REMARKS

These amendments and remarks are in response to the Non-Final Office Action mailed April 20, 2004 in the above-captioned application. Claims 1-26 are pending in this application. Claims 14 and 15 were amended in a preliminary amendment filed June 30, 2003. Claims 1-20 have been allowed. Claims 21-26 have been rejected.

Fig.2
<Prior Art>

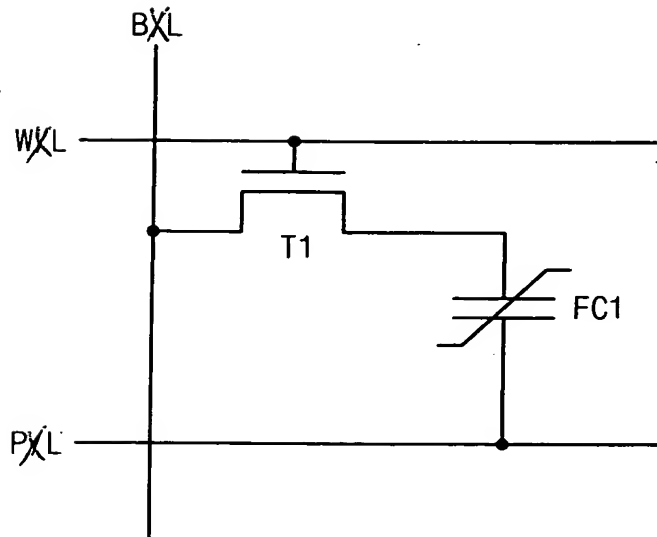
Fig. 2 – B/L, W/L, and P/L: Applicants submit herewith a replacement drawing sheet wherein "B/L," "W/L," and "P/L" have been replaced with "BL," "WL," and "PL," respectively.

Fig.3a
<Prior Art>

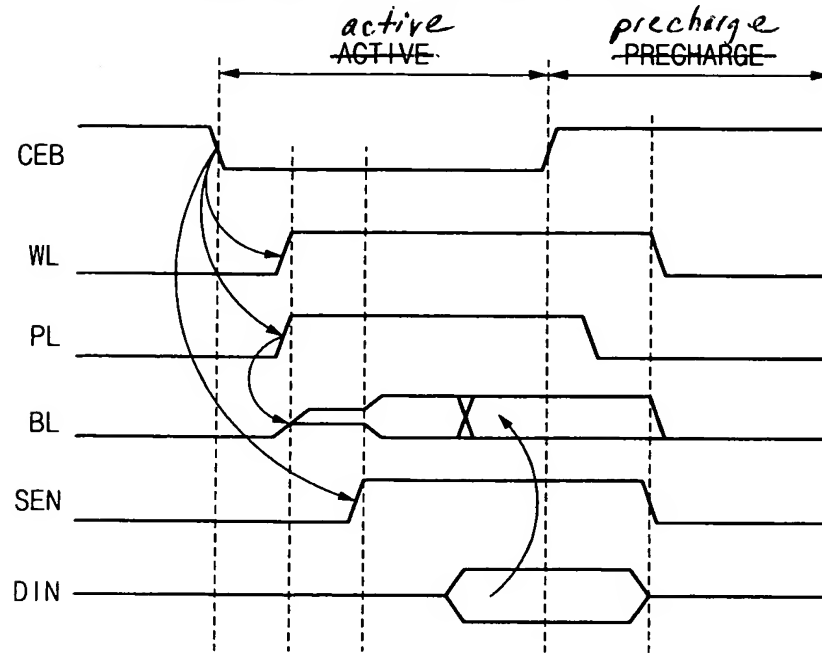
Fig. 3a – CEB, SEN, ACTIVE and PERCHARGE: Applicants submit herewith a replacement drawing sheet wherein the uppercase letters in "ACTIVE" and "PRECHARGE" have been replaced by lowercase letters. The specification has been amended above to replace "CSB" with "CEB" to correct a typographical error, and to add a description of "SEN" consistent with the description mentioned at page 4, line 23 of the specification.

Fig.3b
<Prior Art>

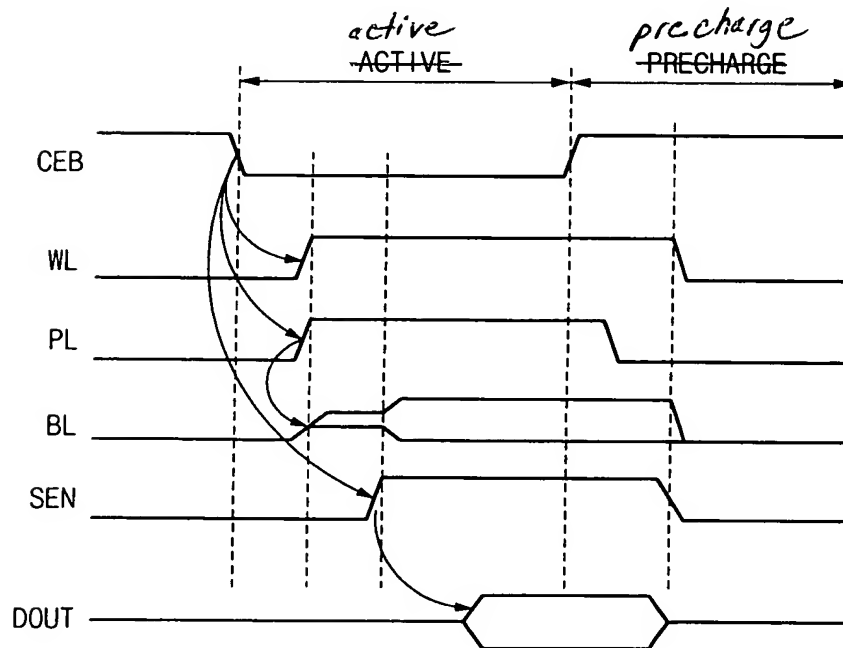
Fig. 3b - CEB, SEN, DOUT, ACTIVE and PRECHARGE: Applicants submit herewith a replacement drawing sheet wherein the uppercase letters in ACTIVE and PRECHARGE have been replaced by lowercase letters. The specification has been amended above to replace "CSB" with "CEB" to correct a typographical error, and to add a description for "DOUT." Applicants note that "SEN" is mentioned at page 4, line 23 of the specification.

Fig.12

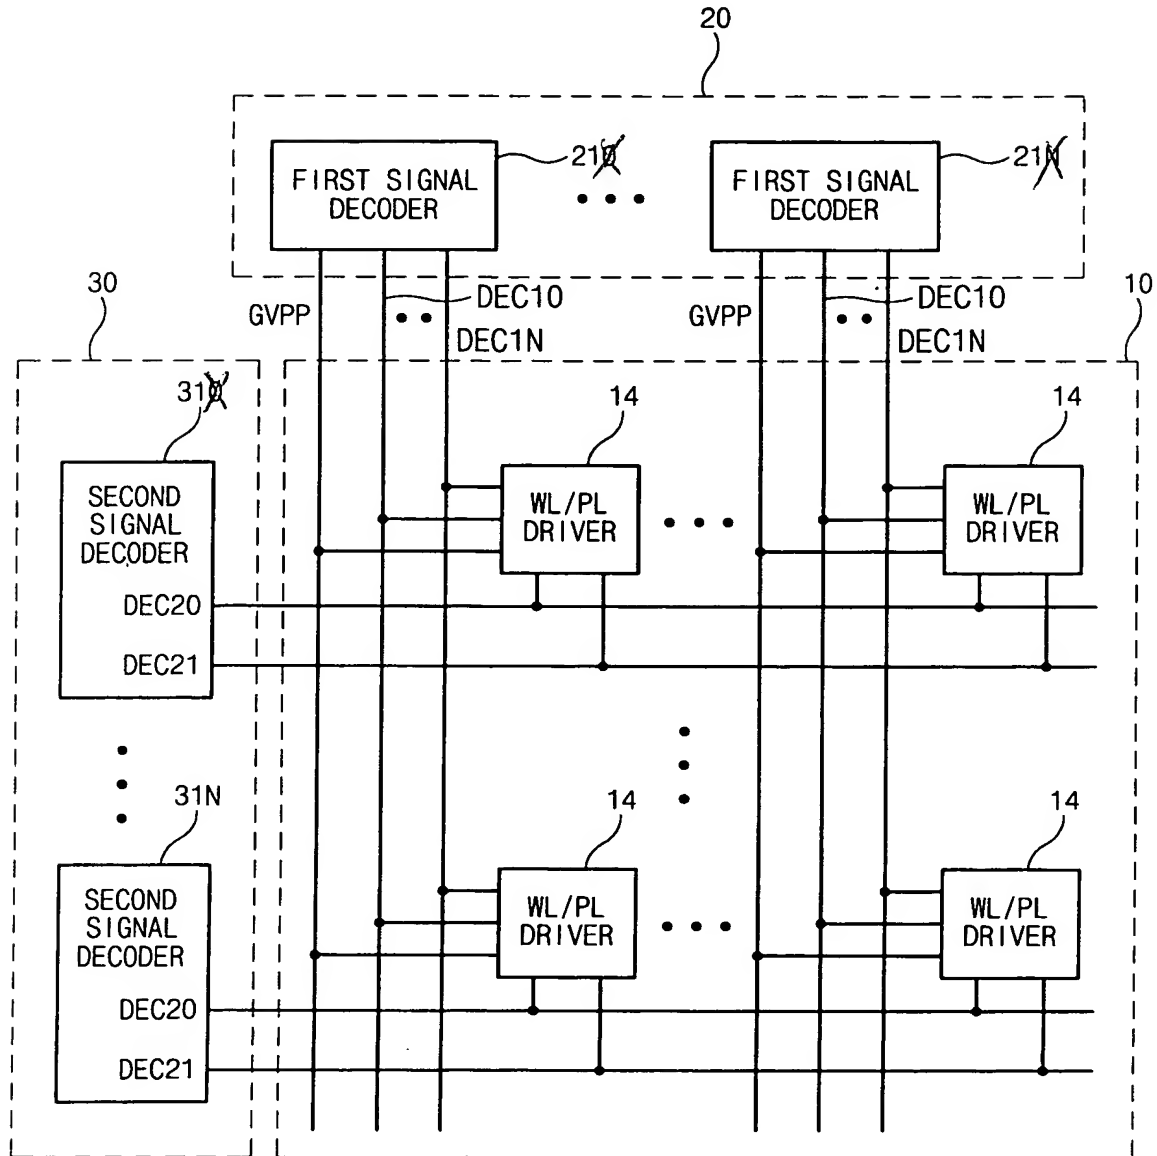
Fig. 12 - 210 and 310: Applicants submit herewith a Replacement Sheet drawing wherein the reference numerals "210" and "21N" have been replaced with "21", and "310" has been replaced with "31".

Fig.13

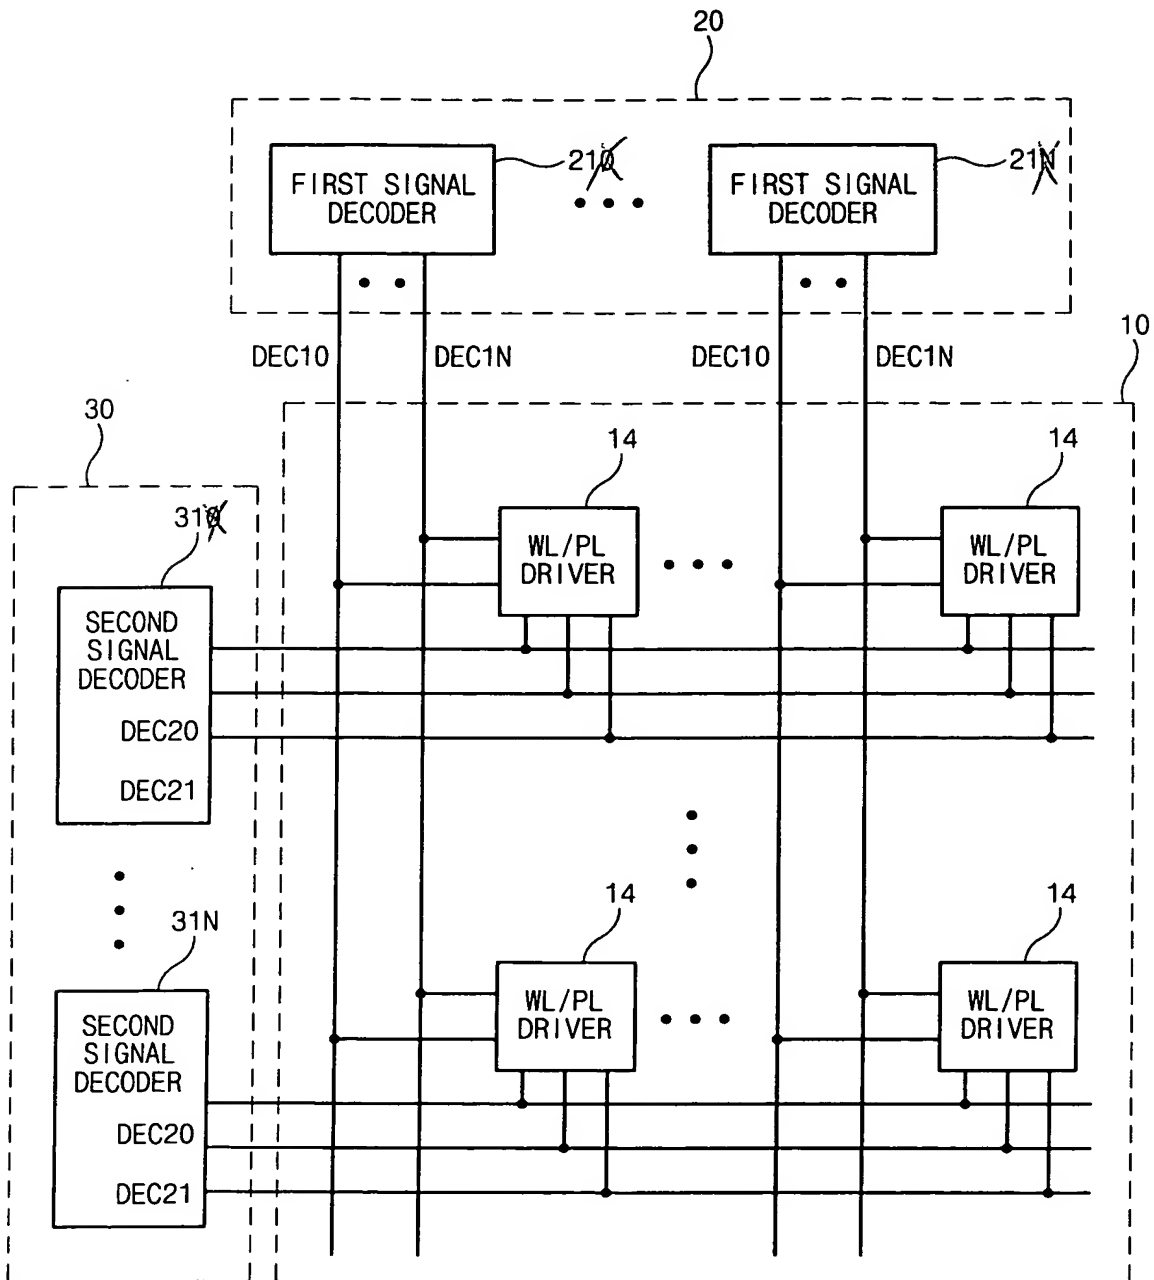
Fig. 13 - 210 and 310: Applicants submit herewith a Replacement Sheet drawing wherein the reference numerals "210" and "21N" have been replaced with "21", and "310" has been replaced with "31".

Fig.14

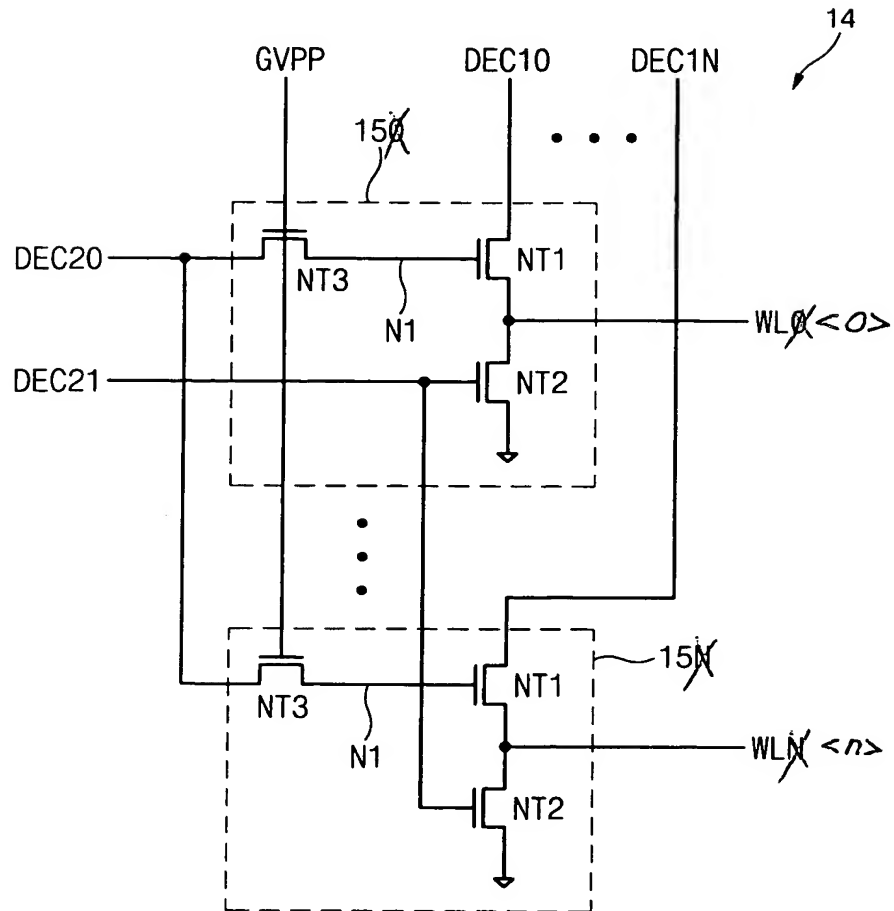
Fig. 14 - 150 and WL0: Applicants submit herewith a Replacement Sheet drawing wherein the reference numerals "150", "WL0", "15N", and "WLN" have been replaced with "15", "WL<0>", "15", and "WL<n>".

Fig.15

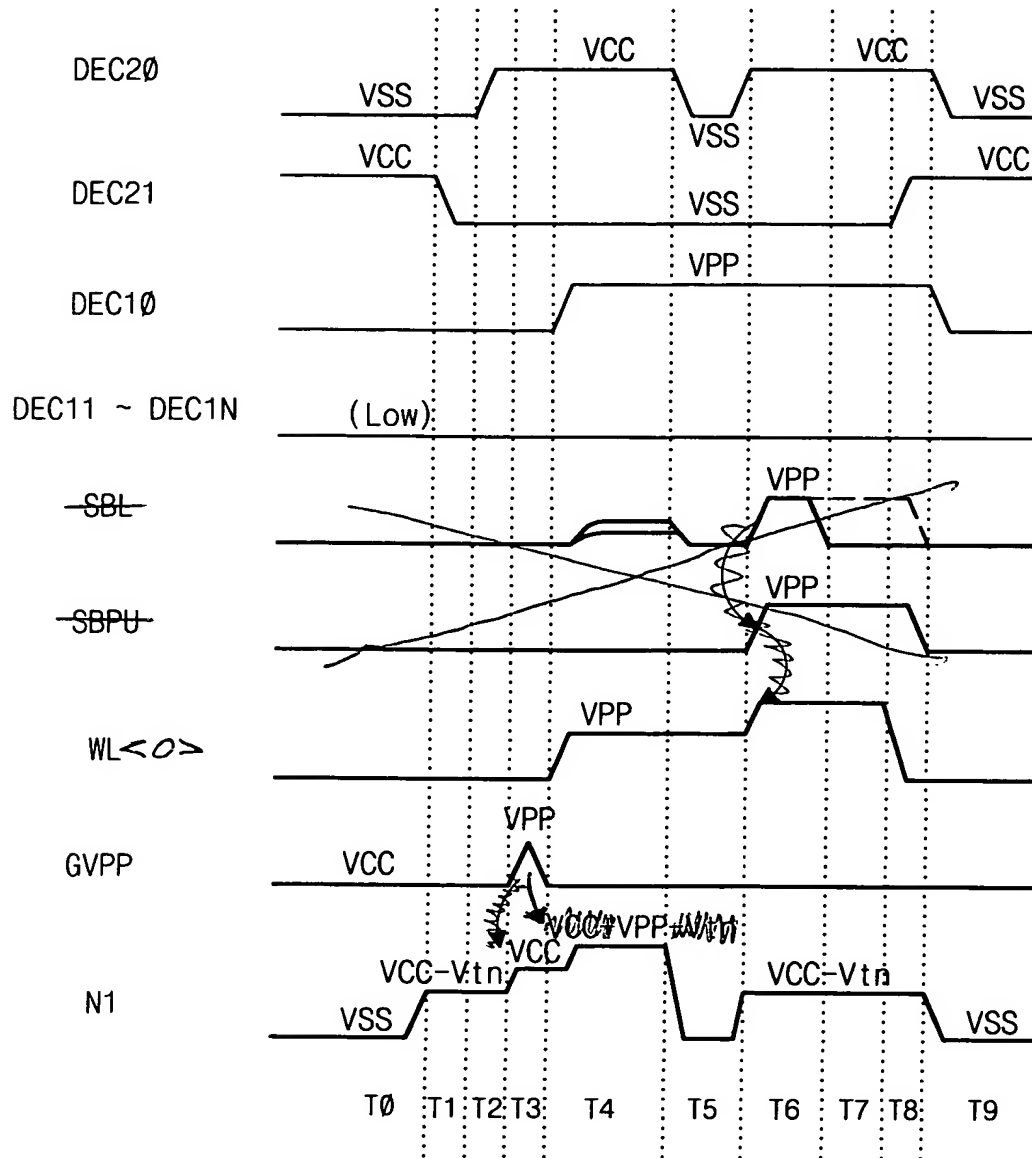
Fig. 15 - DEC10, DEC20, SBL, and VCC+VPP-Vtn: Applicants submit herewith a Replacement Sheet drawing wherein "SBL" and "SBPU" have been deleted. "WL" and "VCC+VPP-Vtn" have been replaced with "WL<0>" and "VPP", respectively, to be consistent with the specification. The specification has been amended above to add descriptions for "DEC10" and "DEC20."

Fig.16

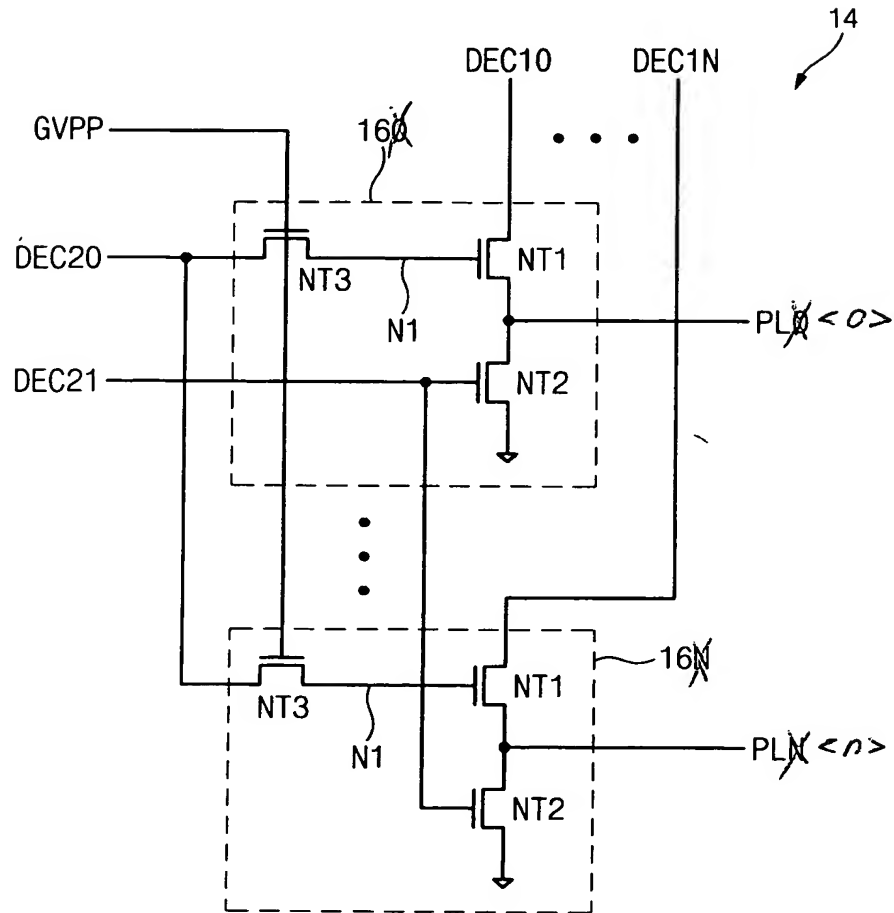
Fig. 16 - 160 and PL0: Applicants submit herewith a Replacement Sheet drawing wherein "160", "PL0", "16N", and "PLN" have been replaced with "16", "PL<0>", "16", and "PL<n>", respectively.

Fig.17

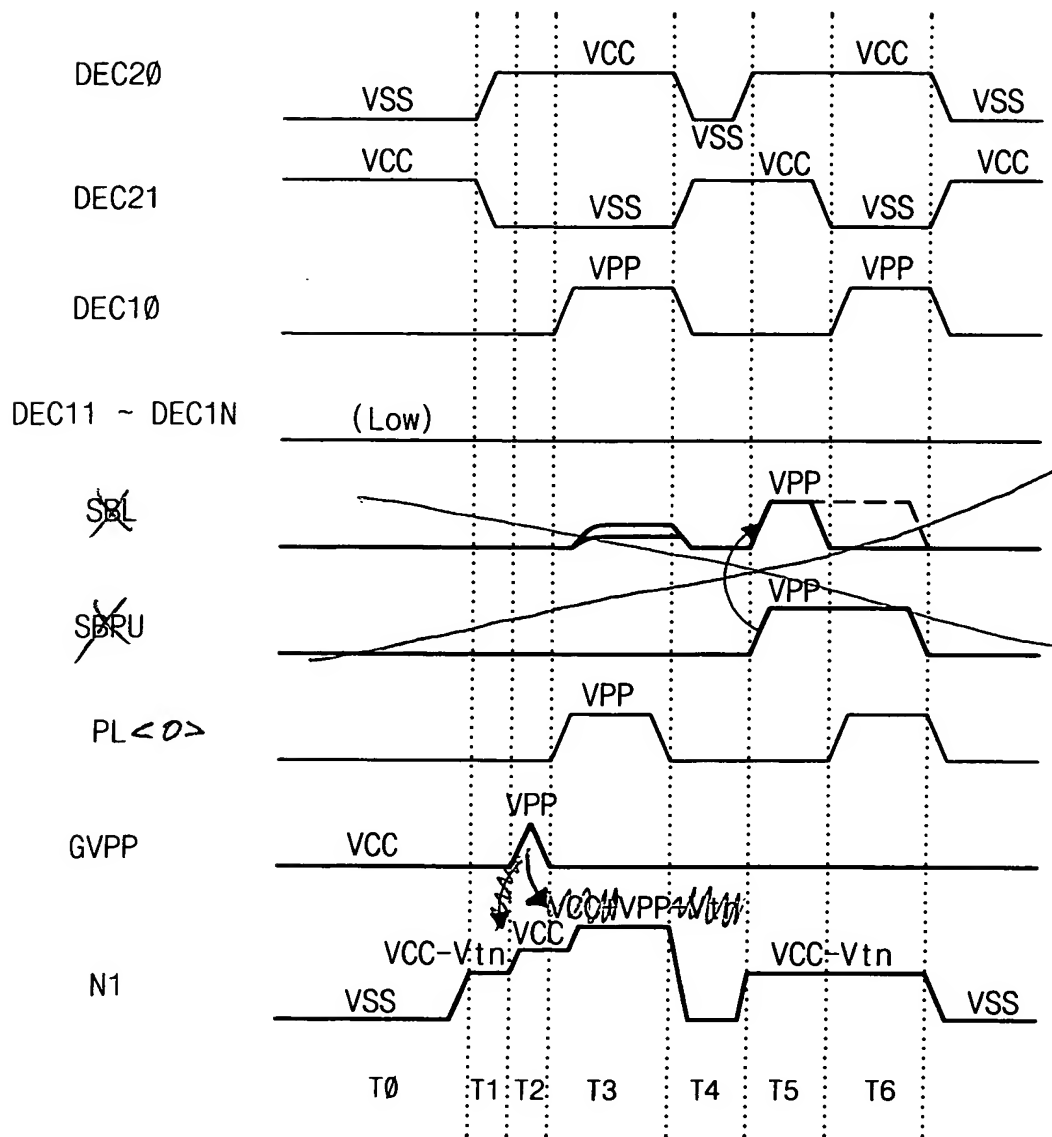
Fig. 17 - DEC10, DEC20, and VCC+VPP-Vtn: Applicants submit herewith a Replacement Sheet drawing wherein "SBL" and "SBPU" have been deleted. "PL" and "VCC+VPP-Vtn" have been replaced with "PL<0>" and "VPP", respectively, to be consistent with the specification. The specification has been amended above to add a description for "DEC10" and "DEC20."

Fig.21

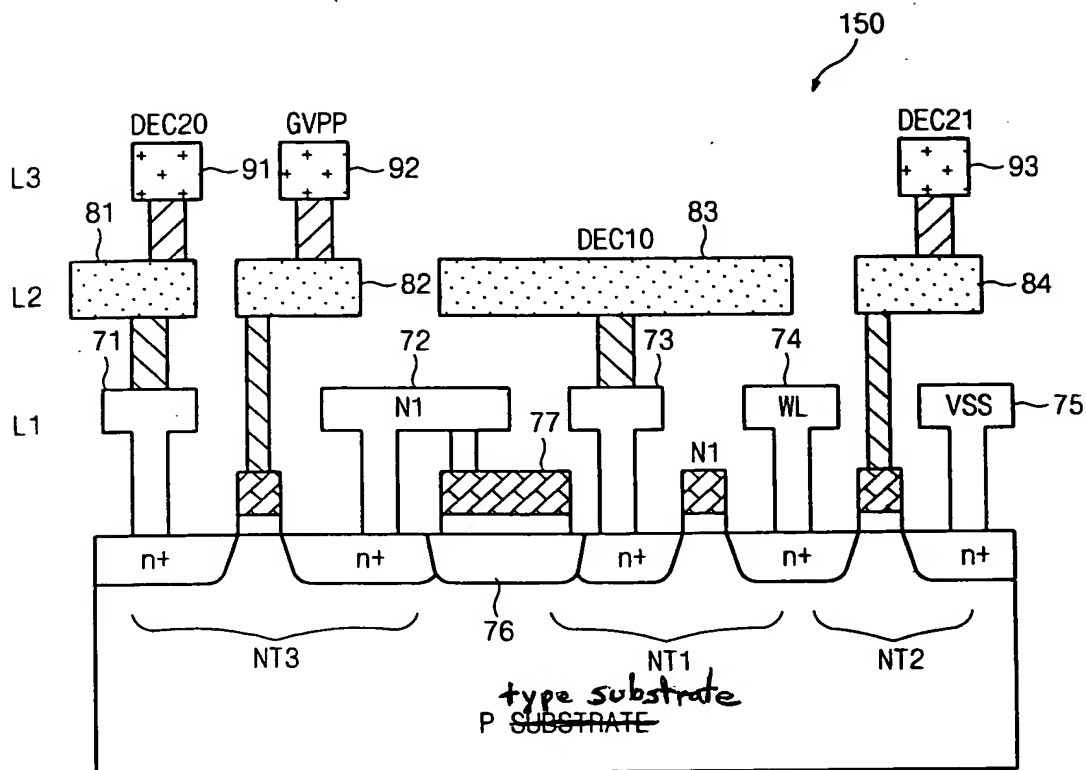
Fig. 21 - n+ and P SUBSTRATE. Applicants submit herewith a Replacement Sheet drawing wherein "P SUBSTRATE" has been replaced with "P type substrate." Applicants have amended the specification above to refer to "n+."
